Application Note AN-1099

IRS210(6, 64) and IR210(6, 64) Comparison

<table><tr><th>IR210(6,64)</th><th>IRS210(6,64)</th></tr><tr><td>
Figure 6A. Turn-on Rise Time vs. Temperature</td><td>
Figure 6A. Turn-On Rise Time vs. Temperature</td></tr></table>

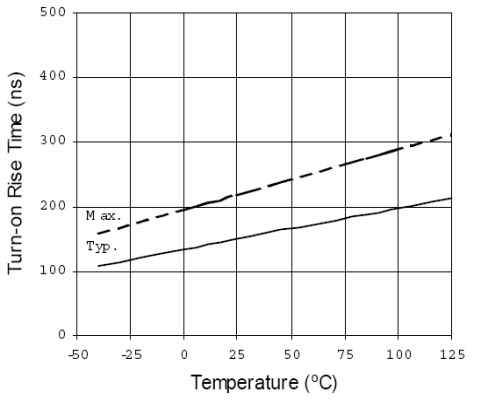
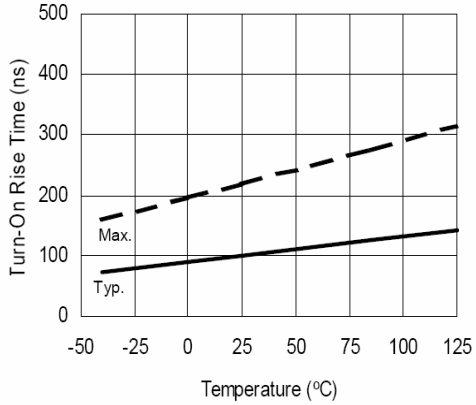
The IRS210(6,64) have faster rise and fall times when compared to the IR210(6,64) HVICs.

Figure 8A. Logic "1" Input Voltage vs. Temperature

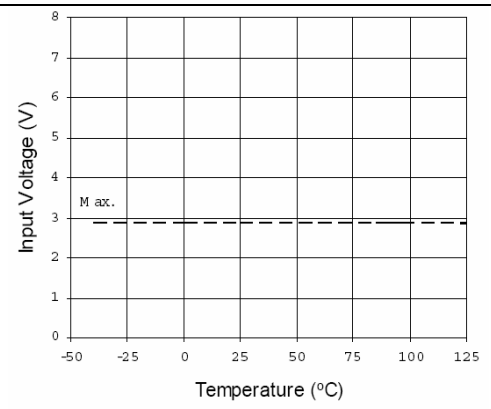
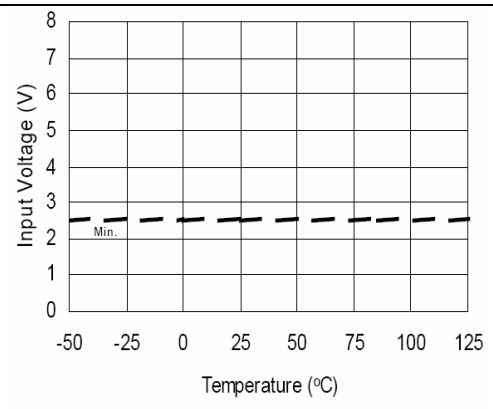
1. V_{IH} is reduced to 2.5 V for better 3.3 V logic compatibility.
2. The V_{OH} and V_{OL} are tested using a new standardized test condition of Io=2 mA. The output driver's on resistance is lower for IRS210(6,64), which improves immunity against the Miller effect.
3. The typical values for I_{O+} and I_{O-} are increased, which allows faster switching.
